TOWN SALEM — BRIDGE NO. 065/069

FEDERAL PROJECT I-93-1(3)11 — STATE PROJECT F-3688-B

SPUR LINE OVER POLICY ROAD

ABUTMENT REINFORCEMENT

SECTION A-A

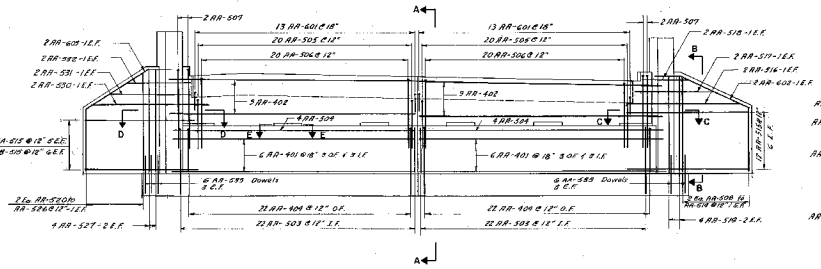
"B"
Note: Abut "B" increased in height
Extend AA-503 @ 12" with AA-503A
AA-#5 by 2'-6" g.tr.
Extend AA-504 @ 12" with AA-504A
AA-#4 by 2'-3" g.tr.
Add additional AA-401 Bars @ 12"
1-#4 by 21'-9" g.tr.
